**Bulletin #** SR-5K-810

## SERVICE BULLETIN

Ride Name: Cliff Hanger

**Abstract of Issue:** The following is a procedure for upgrading hardware on the pivot pins of the upper and lower hanger blocks.

**CLIFF HANGER BULLETIN PI03040K-02**  
**LUBRICATION OF UPPER AND LOWER HANGER BLOCK PINS**

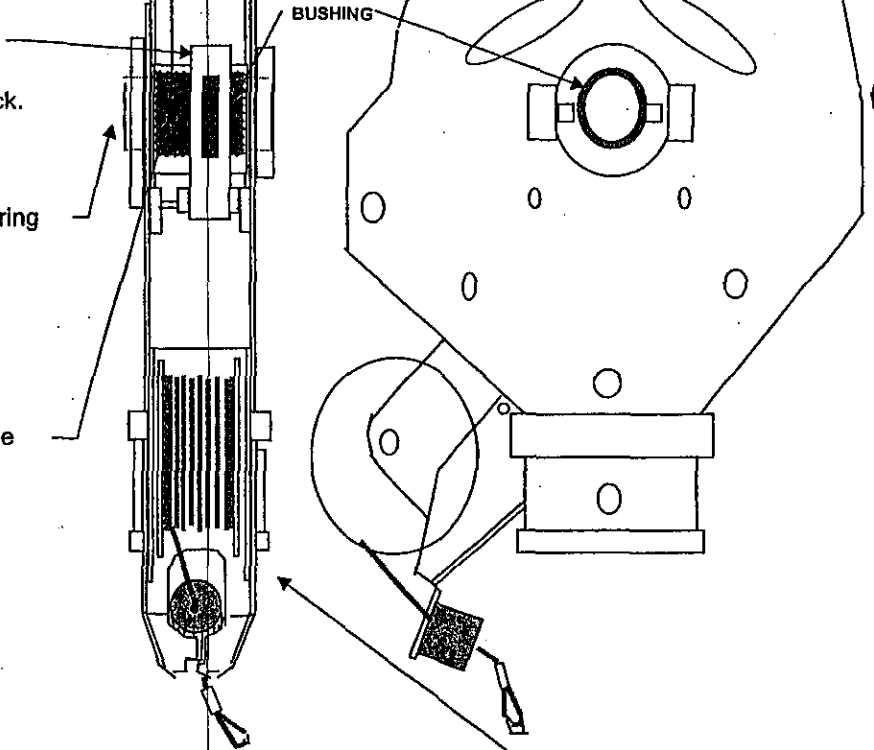
Use the previously installed 1/4" roll pins as ports to inject lubricant onto the upper hanger block shaft. Lubricate shaft with any chain lubricant that is clear and non-foaming. Lubricant should be similar to Maxima Products Chain Guard which is used for chain care. Using the plastic nozzle extension, spray lubricant into roll pins while rotating the hanger block on its shaft.

To lubricate the lower hanger block shaft a roll pin must be installed. To install the roll pin follow the instructions below;

- 1 Remove safety strap held in place with 2 bolts.
- 2 Disconnect shock absorber from lower hanger block.
- 3 Remove hanger block shaft by removing the snap ring and the cotter pin. Remove the hanger block shaft. Remove the lower hanger block.
- 4 Drill 1/4" hole thru the lower hanger block shaft tube and thru its bushing. Drill hole 1" from edge and centered. Insert 1/4 x 1/2" roll pin and re-install lower hanger block.

Use the previously installed 1/4" roll pin as a port to inject lubricant onto the lower hanger block shaft. Lubricate shaft with any chain lubricant that is clear and non-foaming. Lubricant should be similar to Maxima Products Chain Guard which is used for chain care. Using the plastic nozzle extension, spray lubricant into roll pin while rotating the hanger block on its shaft.

KIT INCLUDES 4 COMPLETE CABLE ASSEMBLIES TO BE INSTALLED

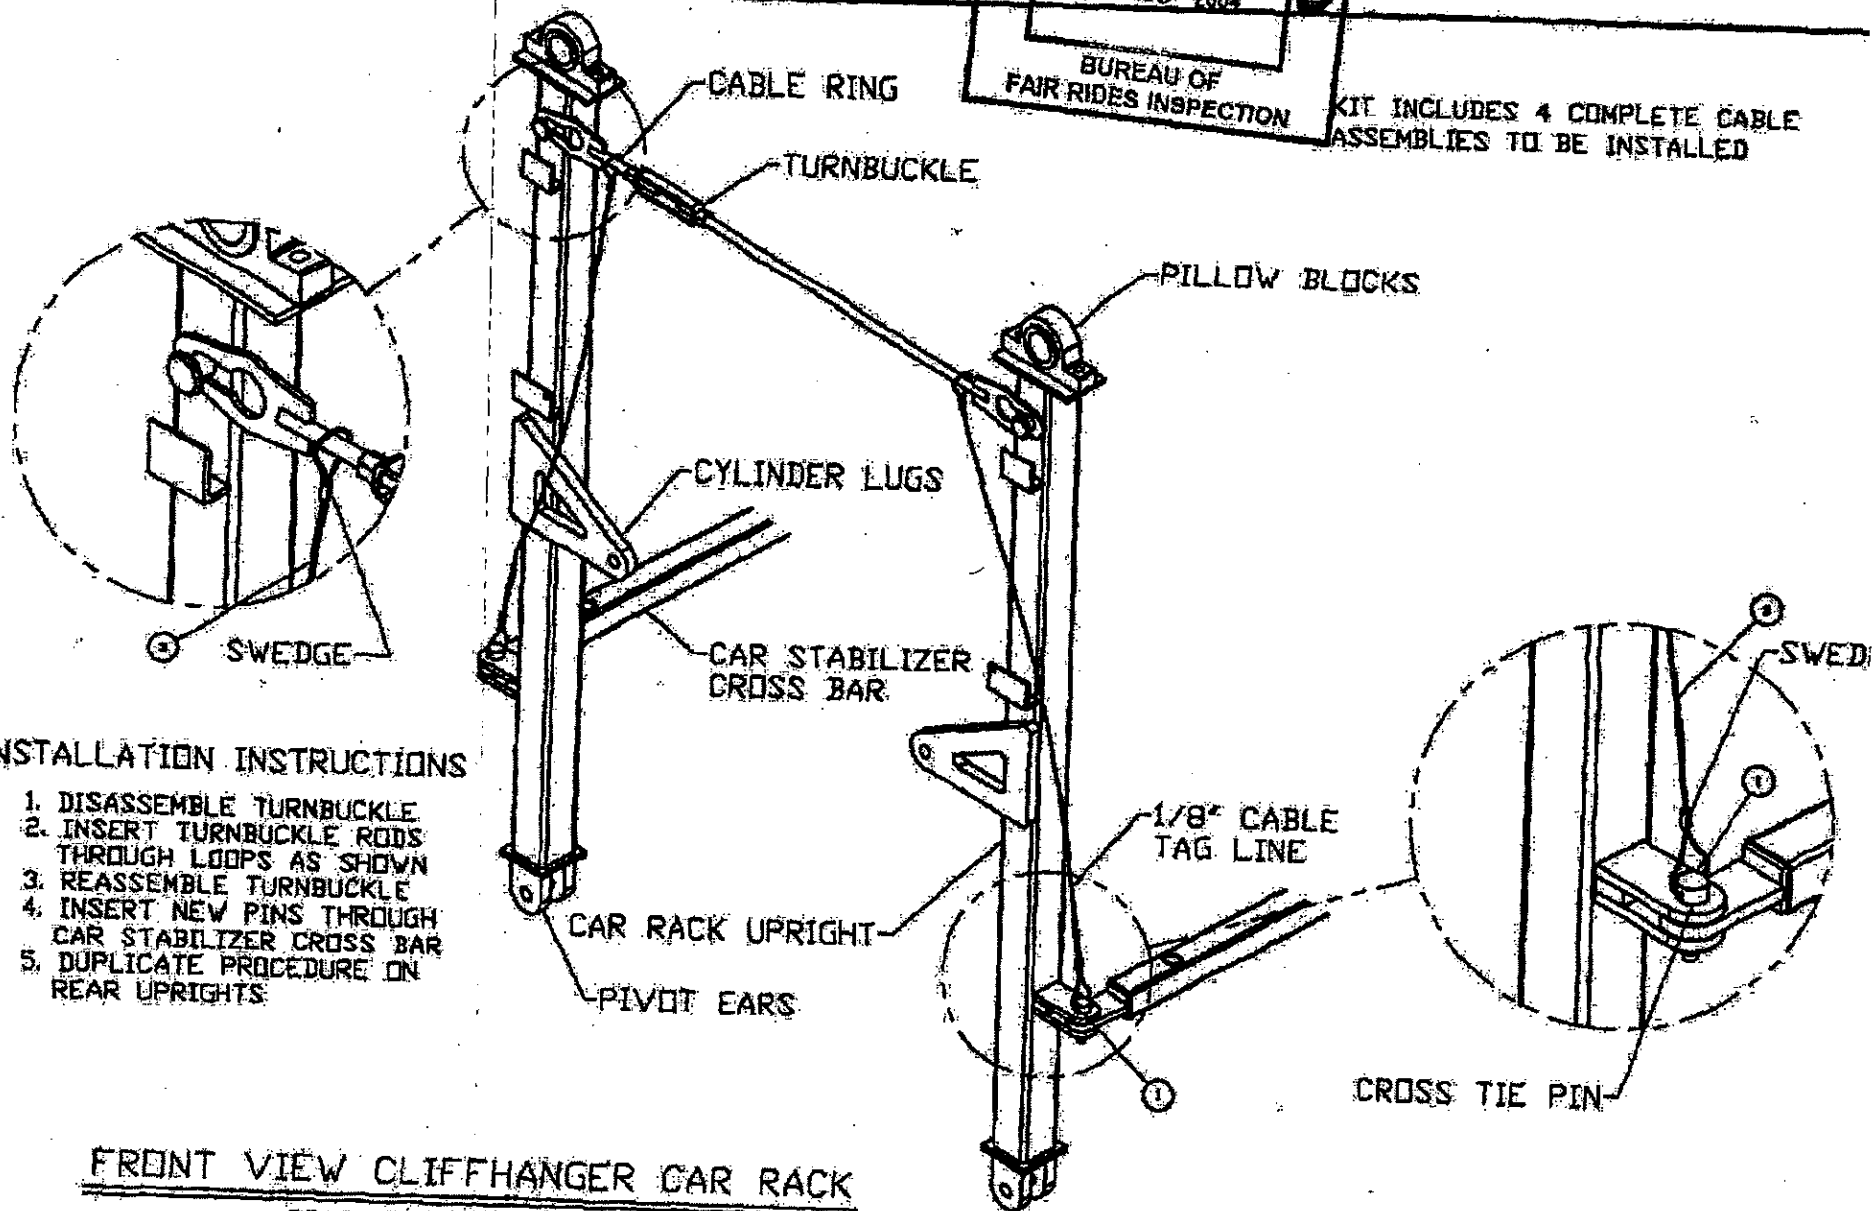
1. Four new Car Stabilizer Bar pins with cables attached must be purchased from Dartron.
2. The cables must be attached to the car rack turnbuckles as shown on Page 2 of this Bulletin.
3. After April 1, 2004 the Cliff Hanger car racks must not be operated unless the Car Stabilizer Cross Bar pins are attached to the turnbuckles as shown on Page 2.
4. Damaged Car Hanger Stems must not be used if two individuals manually lifting the car cannot insert them into the Lower Hanger Block.
5. Until the new pins/cables are installed inspection should be especially vigilant against the use of stems that do not fit correctly into the receiver tubes.

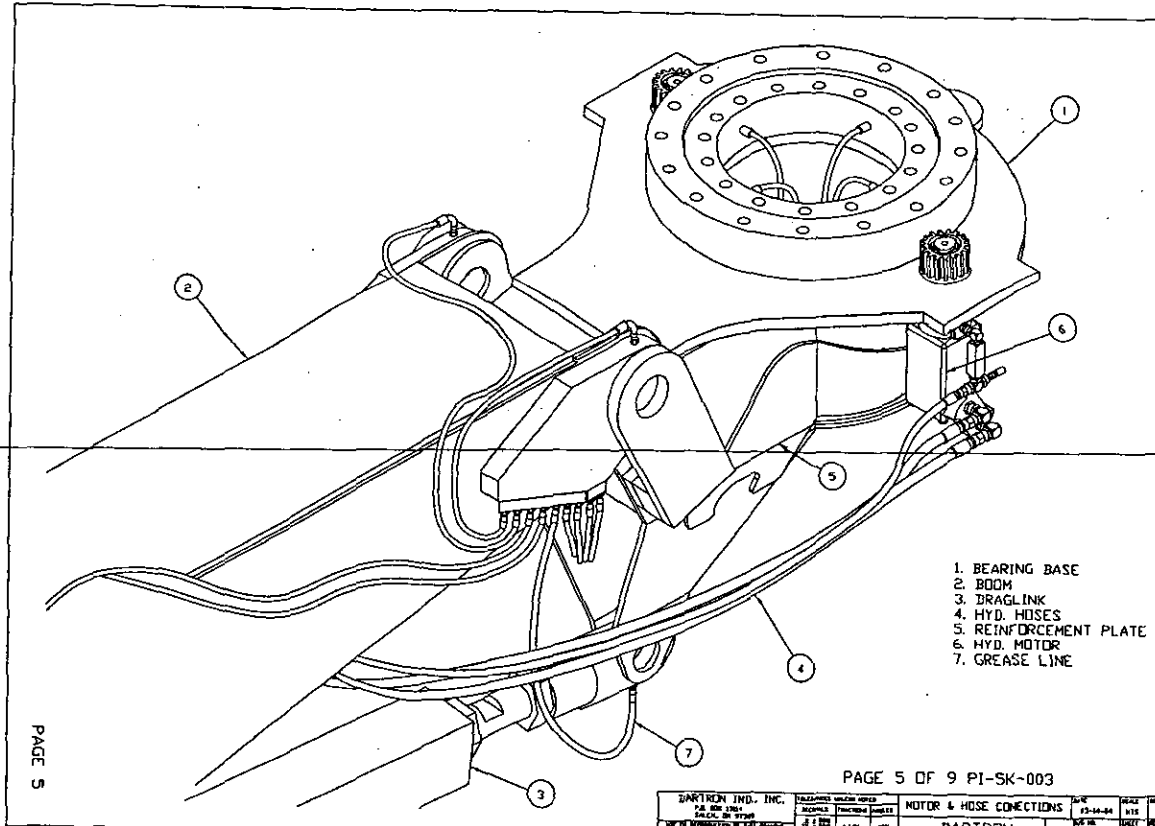
**Step 6:** Fit the Separator web reinforcing plate in position as show on Page 8. The inside edges of the separator web reinforcing plate must be beveled to clear the existing weld. Weld the reinforcing plate to the separator web as shown on Page 8.

**Step 7:** Weld the reinforcing plates to the bearing base using Page 9 for reference details.

### INSTALLATION INSTRUCTIONS

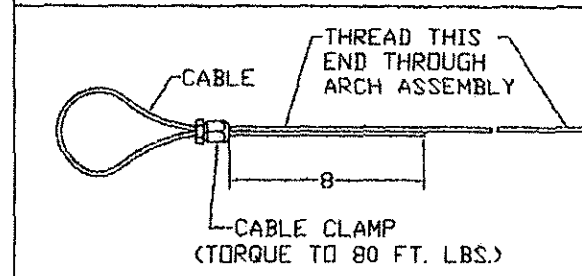
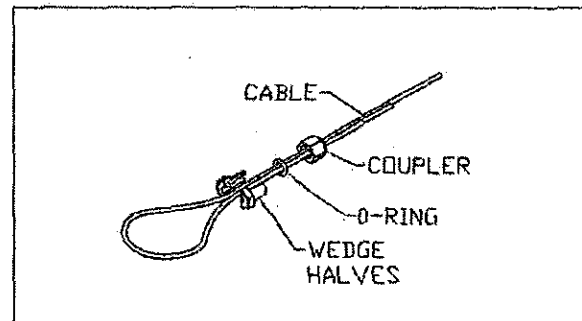
1. SLIDE PART # 2 UP UNTIL IT TOUCHES THE ROUND TUBE.
2. LOCATE AND DRILL HOLES IN THE STEM. 13/32 DIA THRU.
3. INSTALL PARTS #1 THROUGH #5 AS SHOWN.
4. TIGHTEN NUTS #5 180 DEGREES PAST SNUG.
5. INSTALL THE CABLE THROUGH THE ARCH AS SHOWN.
6. ESTABLISH THE FINAL LENGTH OF THE CABLE WITH THE ARCH LAID OVER FLAT. (CRACKED POSITION).
